Lantabur Apparels Ltd Taqwa Fabrics Ltd & Libas Knitwear.

4th November, 2015

Observations

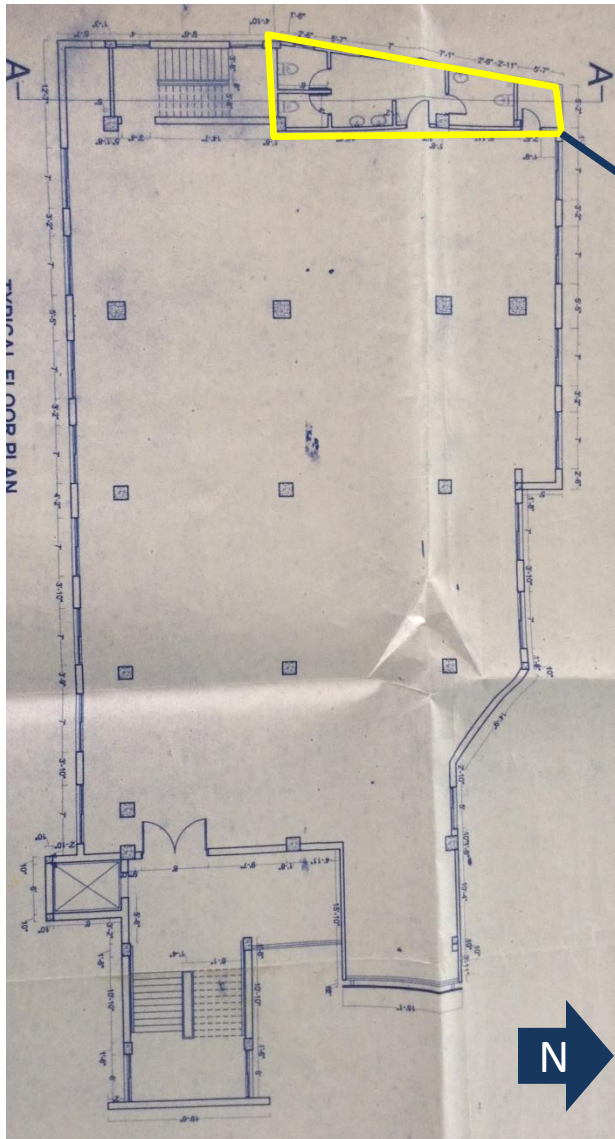
Ground floor columns appear to be overstressed with their working loads

Ground floor large wall panels appear to be slender

Item No.	Observation	Recommended Action Plan	Recommended Timeline
1	Building 1 External Columns adjacent to the cantilevers appear to be stressed in excess of normal design limits and require review	Factory Engineer to review design, loads and columns stresses in the columns based design check to loading set out in BNBC-2006.	6-weeks
2	Building 1 External Columns adjacent to the cantilevers appear to be stressed in excess of normal design limits and require review	Factory Engineer to verify insitu concrete strength by taking 100mm diameter cores from 4 brick aggregate columns . Verify grade of steel reinforcement used.	6-weeks
3	Building 1 External Columns adjacent to the cantilevers appear to be stressed in excess of normal design limits and require review	No further construction should proceed until the above study is completed	6-weeks
4	Building 1 External Columns adjacent to the cantilevers appear to be stressed in excess of normal design limits and require review	Carry out any remedial actions arising form the above study.	6-months

Item No.	Observation	Recommended Action Plan	Recommended Timeline
5	Building 1 Ground floor Large wall panels appear to be slender	Design engineer to review by calculation the capacity of the large brick wall panels to resist the wind and other lateral loads	6-weeks
6	Building 1 Ground floor Large wall panels appear to be slender	Carry out any remedial actions from the above review	6-months
7	Building 1 Toilets and 250mm thick external walls build on large cantilever average 1.75m	Building Engineer to review by calculation the loads on the cantilevers and their ability to carry these loads	6-weeks
8	Building 1 Toilets and 250mm thick external walls build on large cantilever average 1.75m	Carry out such remedial actions as maybe required from the above study	6-months
9	Building 1 Water tank on drawing to be constructed on roof slab	The water tank on the roof needs to form part of the review for the heavily loaded edge columns. (refer to Item 1).	6-weeks

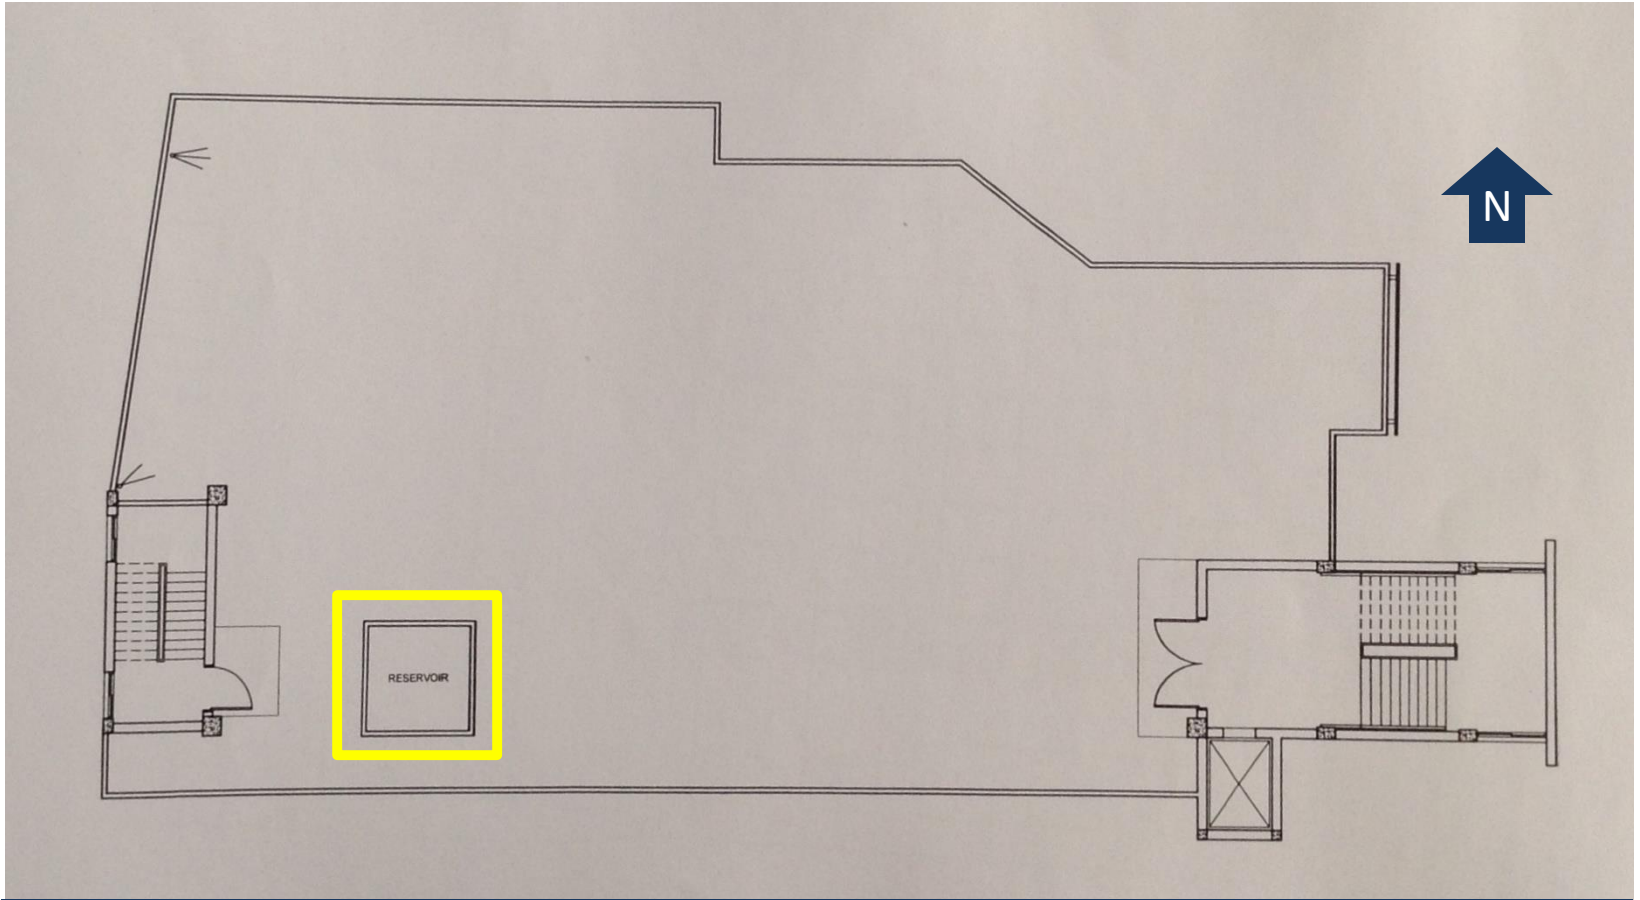
Toilets are on cantilever

Water tanks on drawings to be constructed on roof slab

10	Building 1 Water tank on drawing to be constructed on roof slab	Construction of the tank to be put on hold until such time the column capacities have been justified.	6-weeks

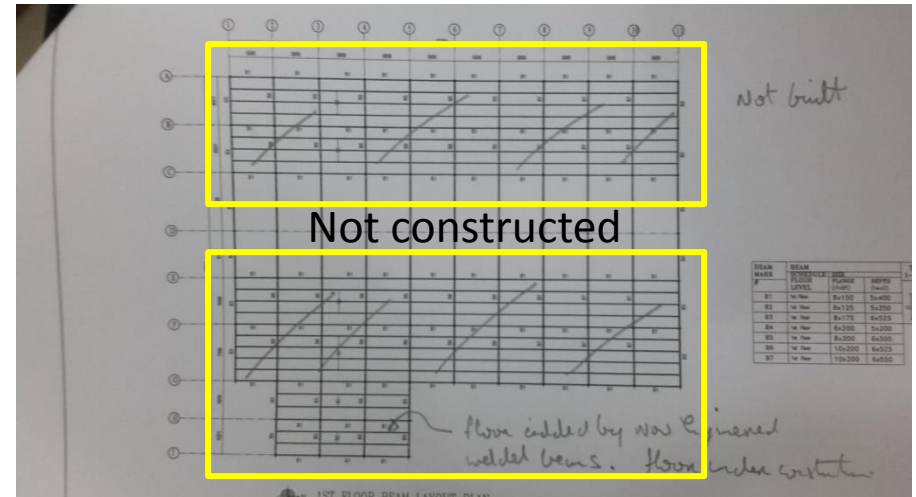
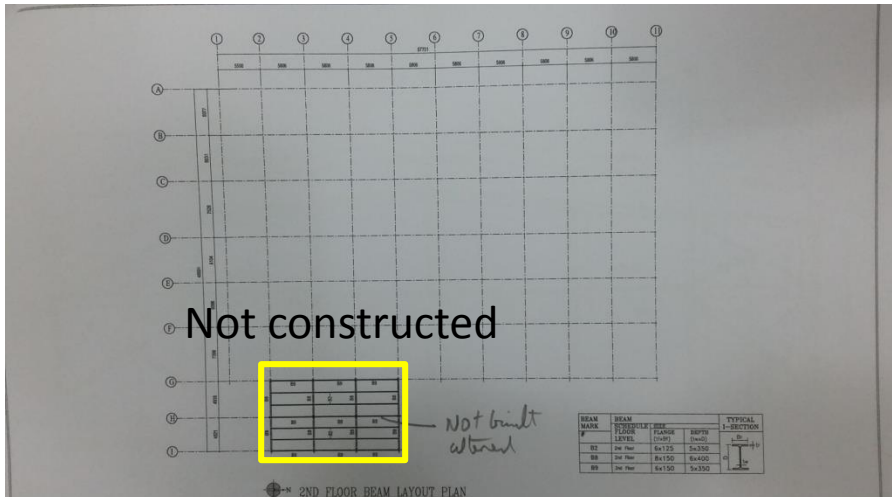
Stone chips observed at ground floor column

Shed 1

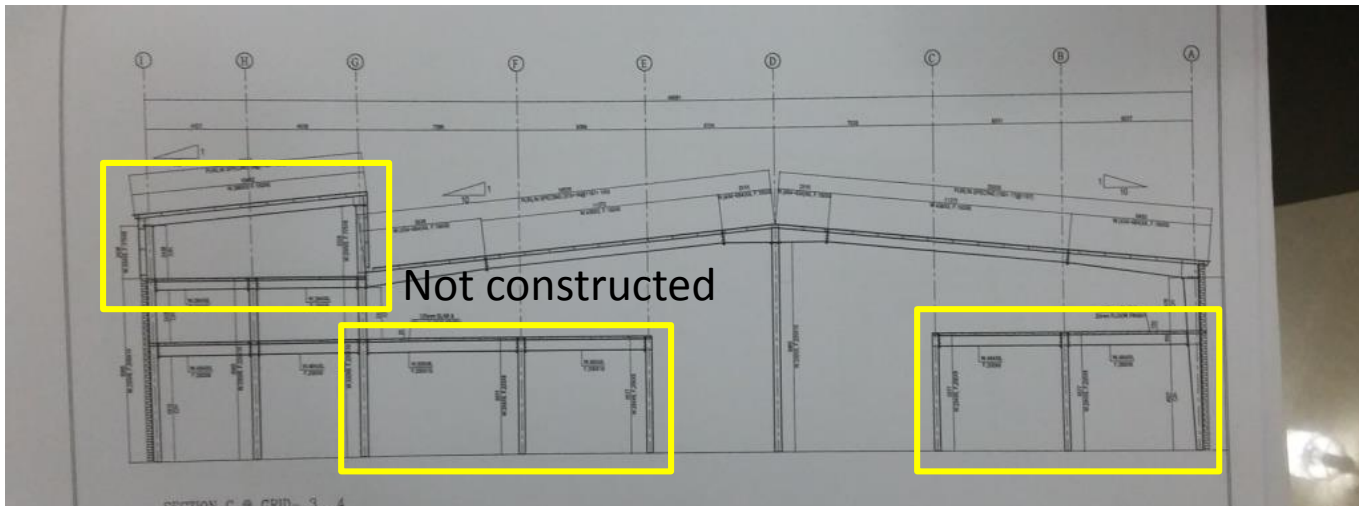
Structural drawing is different from as constructed building

Structural drawing is different from as constructed building

Non Engineered lean-too structure under construction as add-on to main shed

Item No.	Observation	Recommended Action Plan	Recommended Timeline
11	Shed 1 Structural drawings different from as-constructed building	Engineer to revise drawings to reflect the as-built structure and to include any remedial works following this review	6-weeks
12	Shed 1 Non Engineered lean-to structure under construction as add-on to main shed	Engineer to review by calculation the non-engineered structure currently under construction. Engineer to propose alternations to make the design conform with code requirement or instruct its removal.	6-weeks
13	Shed 1 Non Engineered lean-to structure under construction as add-on to main shed	No further works to be carried out on this structure until after the Engineering review	6-weeks
14	Shed 1 Non Engineered lean-to structure under construction as add-on to main shed	Carry out the remedial works from the above study	6-months

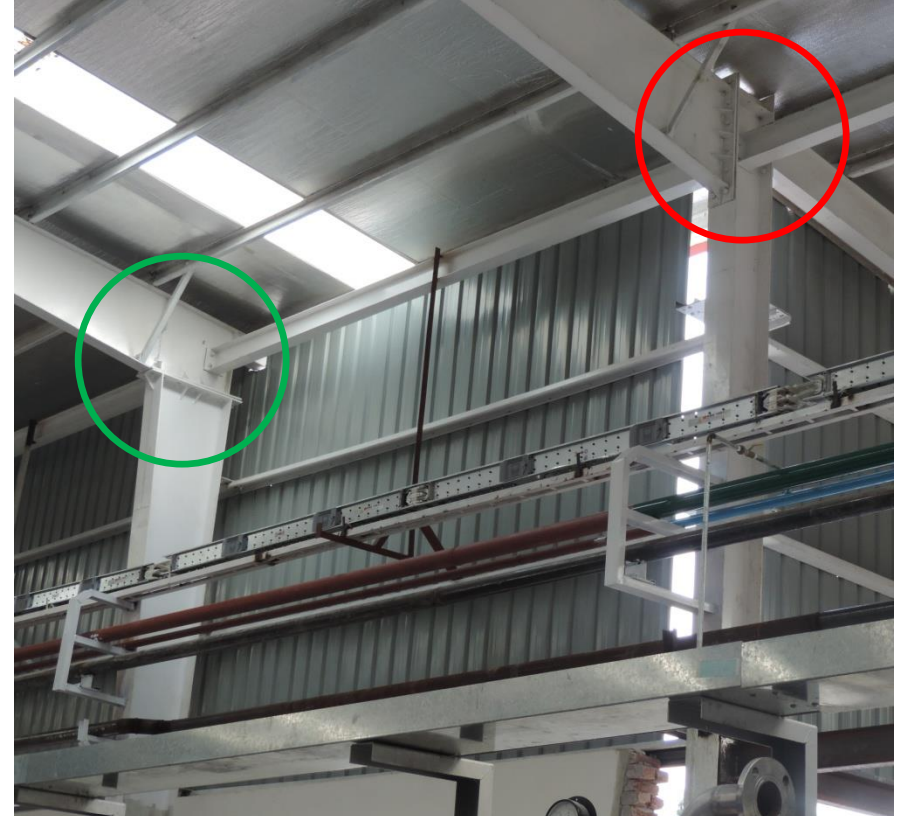
Non engineered connections to mezzanine floor. On site welding

Portal 2 to 5 have no moment connection with column. (ability to act as a portal)

Lack of head restraint to masonry infill wall panels

Item No.	Observation	Recommended Action Plan	Recommended Timeline
15	Shed 1 Non – engineered connections to mezzanine floor. On site welding	Engineer to review by calculation the non-engineered structure currently under construction. Engineer to propose alternations to make the design conform with code requirement in particular the member connections.	6-weeks
16	Shed 1 Non – engineered connections to mezzanine floor. On site welding	No further works to be carried out on this structure until after the Engineering review	6-weeks
17	Shed 1 Non – engineered connections to mezzanine floor. On site welding	Carry out the remedial works from the above study	6-months
18	Shed 1 Portal 2 to 5 have no moment connection with column. (ability to act as a portal)	Engineer to review by calculation the ability of the above frames to act as portals in particular its ability to resist lateral loading.	6-weeks
19	Shed 1 Portal 2 to 5 have no moment connection with column. (ability to act as a portal)	Carry out the remedial works from the above study	6-months

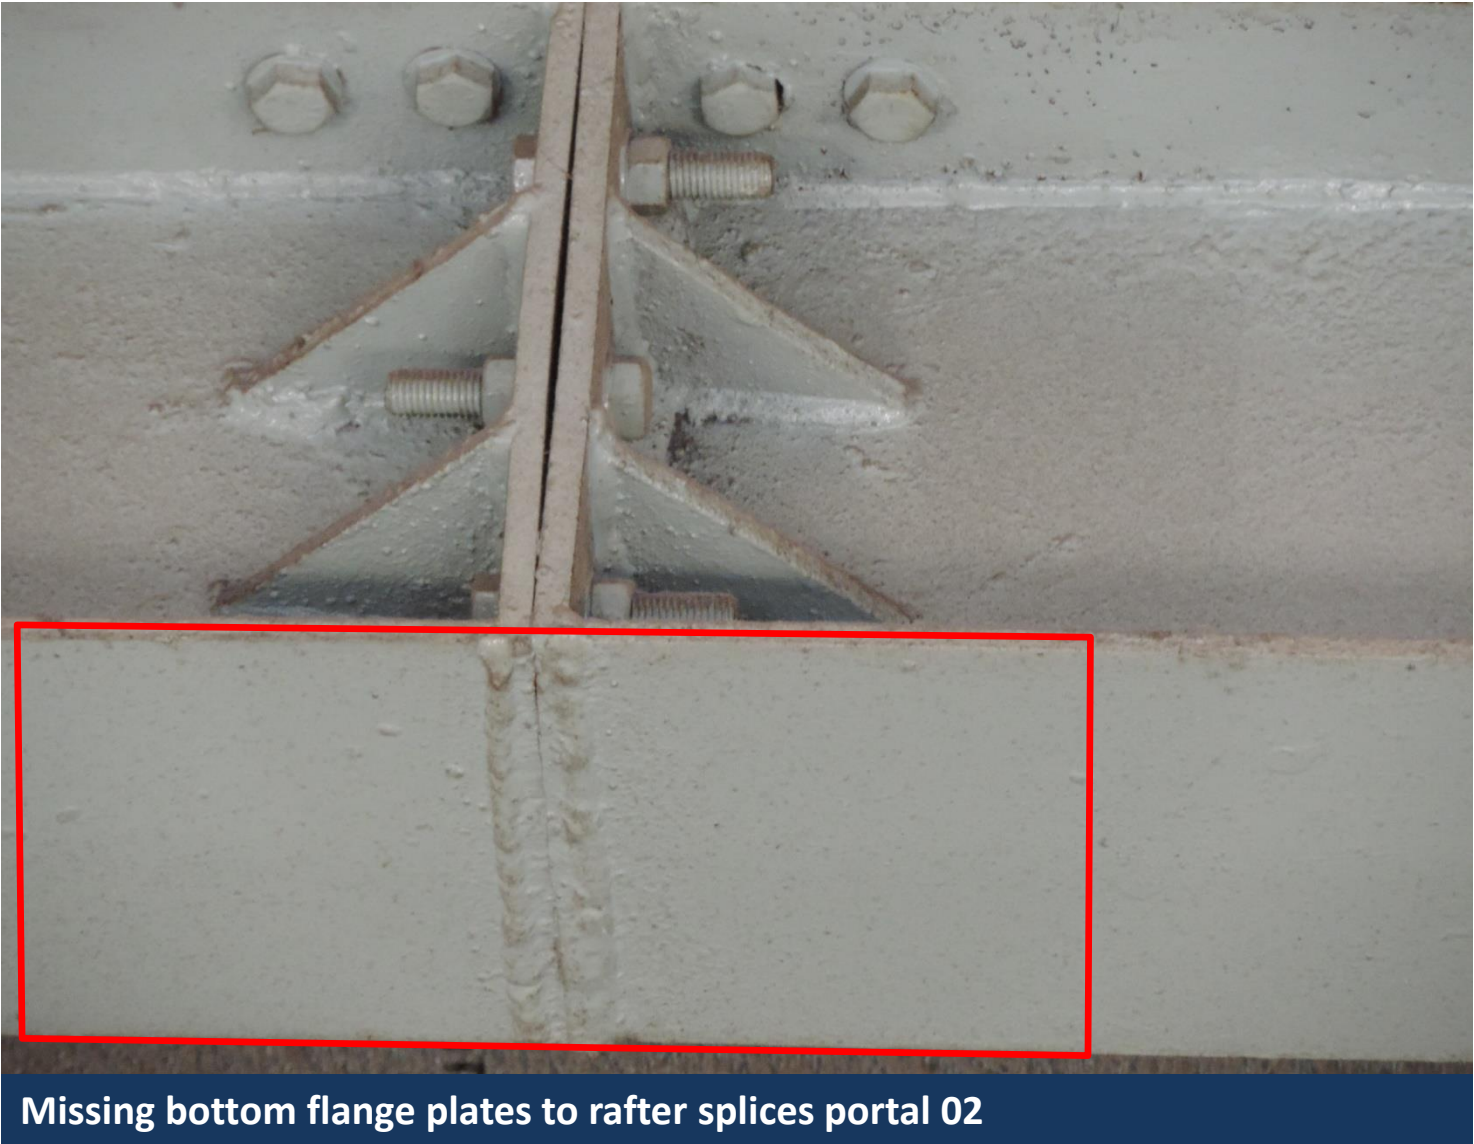
Gable columns constructed half height in concrete

25	Shed 2 Gable columns constructed half height in concrete	Carry out the remedial works from the above study	6-months

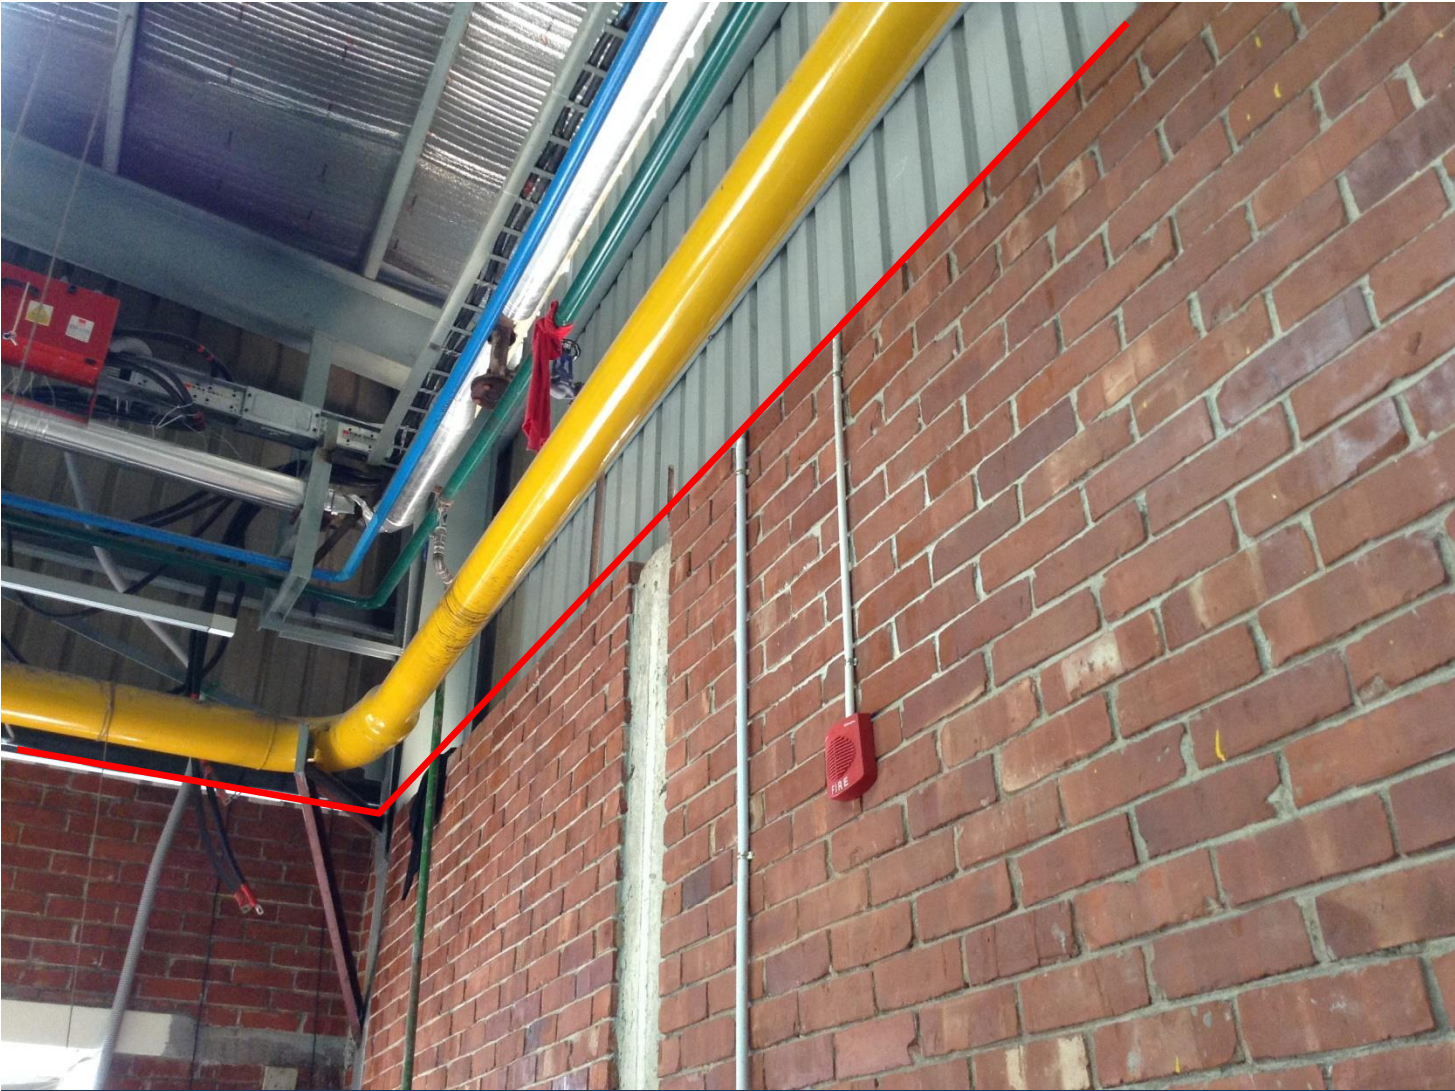
Open moment joint in portal 10

Item No.	Observation	Recommended Action Plan	Recommended Timeline
26	Shed 2 Open moment joint in portal 10	Engineer to review the joint as-built on site and propose remedial works	6-weeks
27	Shed 2 Open moment joint in portal 10	Carry out the remedial works from the above study	6-months
28	Shed 2 Missing bottom flange plates to rafter splices portal 02	Engineer to review the splice connections and propose remedial work to correct the splice joint	6-weeks
29	Shed 2 Missing bottom flange plates to rafter splices portal 02	Carry out the remedial works from the above study	6-months
30	Shed 2 Gable masonry wall has no head restraint	Engineer to review the capacity of the wall panels without head restraint to resist lateral loading and make suitable recommendations on remedial works	6-weeks
31	Shed 2 Gable masonry wall has no head restraint	Carry out the remedial works from the above study	6-months
